Access Compliance Report Public Rights-of-Way (Curb Ramps)

Intersection ID: N/A Main Street: E_4TH_ST **Cross Street: S CALDWELL ST** Location: S ADA ID: 8E084957DBC1 Ramp Type: Perpendicular Initial Pass/Fail: Pass **Overall Compliance: No Severity Score:**

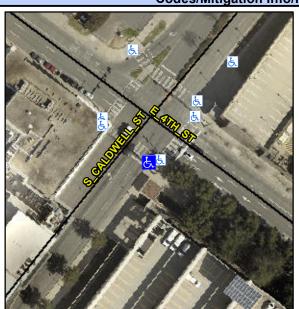
S CALDWELL ST Street 1 Name Stop Condition-Street 2 Signal Street 2 Name N/A Stop Condition-Street 1 N/A Possible Solutions: Remove & Replace Entire Ramp. Surveyor Notes: N/A PROW/ADA: R304.5.3, R305.2
